**TRANSMITTAL OF RESPONSES TO OHIO ENVIRONMENTAL PROTECTION AGENCY
COMMENTS AND THE FINAL INTEGRATED REMEDIAL DESIGN PACKAGE FOR AREA 2,
PHASE I NON-WASTE UNITS CAROLINA AREA**

**RESPONSES TO OHIO ENVIRONMENTAL PROTECTION AGENCY COMMENTS
ON THE DRAFT INTEGRATED REMEDIAL DESIGN PACKAGE FOR
AREA 2, PHASE I NON-WASTE UNITS CAROLINA AREA
(20400-PL-0004, REVISION A)**

(4) RESPONSIBLE DISCIPLINE: E <input type="checkbox"/> M <input type="checkbox"/> C <input checked="" type="checkbox"/> OTHER <input type="checkbox"/>	(4A) RCI/DCN TITLE: Carolina Area Excavation	(11) DCN NO.: 20402-109

DCN 20402-109A
SKETCH 1 OF 2

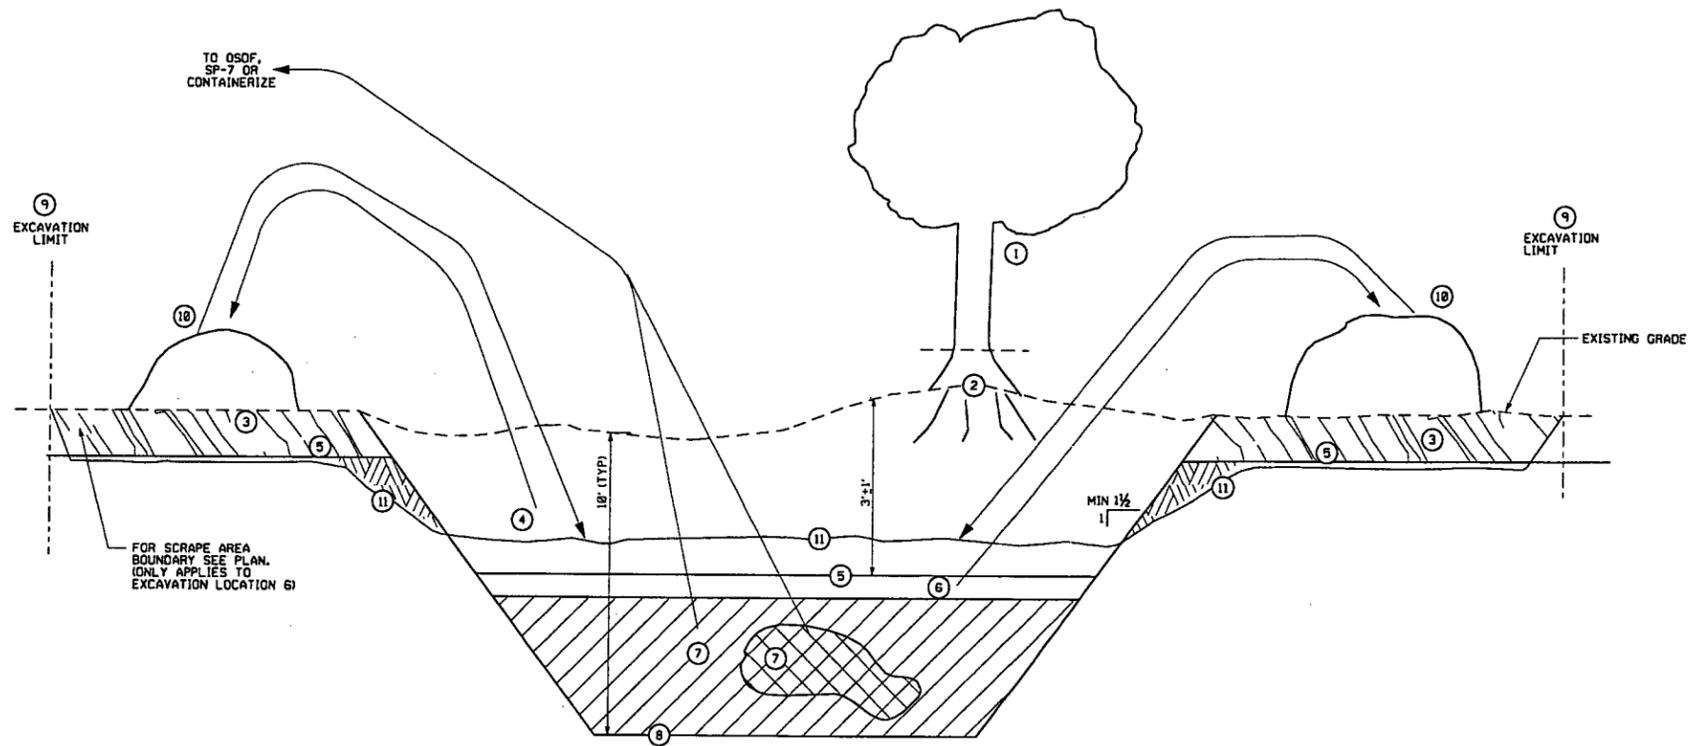
Comment: During walk downs of the Carolina area, numerous locations of surface debris have been seen. No specific references as to how this debris will be handled are made in this document. Along with pulling this surface debris, Ohio EPA feels that a 6-inch scrape in the same area is necessary to make sure all debris is removed. After the scrape, the material must be handled as described in the IP for the 12-inch areas.

Comment: Ohio EPA has concerns that a strict 30-foot trench may not be long enough in some sections of Paddys Run. The document should state that the trench lengths will be field located such that they extend through the berm along the stream bank.

Response: The Design Change Notice (DCN) addresses the removal of the miscellaneous surface debris located throughout the Carolina Area. There were 32 identified surface debris locations identified during electromagnetic scanning and given coordinates, as shown on the DCN. A separate note, General Note 7 of the DCN, addresses the contingency of additional, previously unidentified debris. In addition, the General Note 7 and Excavation Note 5 are to be revised to state that a 6-inch deep area over an approximate 5-foot radius around the debris location is to be scraped to verify that there is no additional debris present.

Action: The DCN will be revised to incorporate the 6-inch scrape over an approximate 5-foot radius around the debris locations. Section 3.3 of the Implementation Plan will also be revised to incorporate a discussion on the handling of miscellaneous debris.

Response: The DCN states that these dimensions are minimum, and therefore the length of the trench is not limited to the 30 feet as stated. Field direction will be such that the trench length can be increased if it is determined to be necessary. OEPA will be notified before start of construction to allow field observation during excavation.

Action: The DCN and Implementation Plan will be revised to state that the trench lengths will be field located such that they extend through the berm along the stream bank. A note will also be added to the DCN referencing agency input prior to and during the excavation of the trenches.
